Certificate of Appropriateness for Minor Alteration

• Exterior alterations on northwest façade of garage structure to remove existing garage doors and windows; enclosure of portions of the wall; installation of new doors and windows; installation of flood barriers; and site improvements.

Case Number	H19016	FMSF#	BD04551
Owner	Kim Nothard		
Applicant	Kim Nothard		
Address	215 SW 14 th Way		
General Location	Northwest corner of SW 14th Way	and SW 2 nd	Court
Legal Description	RIVER HIGHLANDS 10-3 B LOTS 1,2 OF VAC POR OF SW 14TH WAY L		
Existing Use	Single-Family Residential		
Proposed Use	Single-Family Residential		
Zoning	RS-8		
Applicable ULDR Sections	47-24.11.C.3.c.i; 47-24.11.C.3.c.ii;	47-17.7.B	
Landmark/Historic District	Sailboat Bend Historic District		
Authored By	Trisha Logan, Urban Planner III

Photo of North Façade showing Existing Conditions

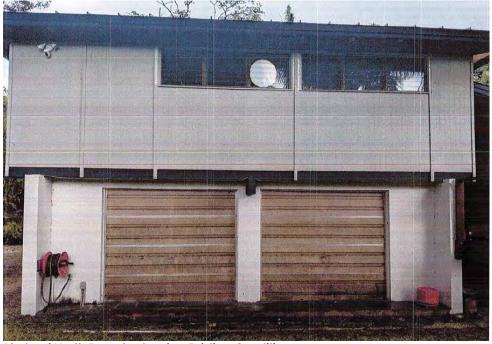
Majority of the proposed scope of work is related to the north elevation of the two-story structure which faces the canal. The original elevation drawing of this façade shows the garage doors as an open carport; however a permit for garage doors was applied for in March of 1969.

At the first level, plans show the removal of the entire wall, including both garage doors, retaining a structural column that is centered between both garage door openings. In each opening, a set of three sliding glass doors will be placed in each opening. Placement of the sliding glass doors will return the structure more in line with the original design where the first floor was completely open as a carport. Set in front of these openings, the elevation drawings show the installation of a new flood barrier that will only be in place when needed for flood protection.

At the second level, plans show the removal of the clerestory jalousie windows, infill of a portion of the wall using the same clapboard siding as the existing, and installation of two sets of three full height windows. The full height windows are reflective of the size of the openings on the east elevation and the series of three openings aim to repear the existing pattern created by the two sets of three jalousie windows that are currently in place.

Proposed North Façade Elevation Drawing of 215 SW 14th Way

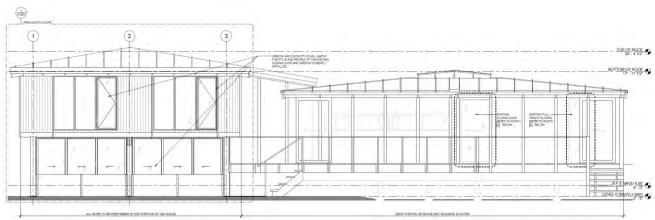
UL	DR, Section 47-24.11.D.3.c.i	Staff Response
a)	The effect of the proposed work on the landmark or the property upon which such	Windows on a historic structure can define the exterior appearance and when replaced with a different window types it can dramatically alter the overall style of the structure.
	work is to be done;	Alterations are located on a façade which faces a waterway, which is considered to be visible from the public right-of-way. Proposed modifications on the first level are reflective on the original design of the open carport. Alterations on the second floor incorporate the scale and rhythm of the existing openings as well as other windows found on the east elevation in proposed modifications.
		Application meets criterion.
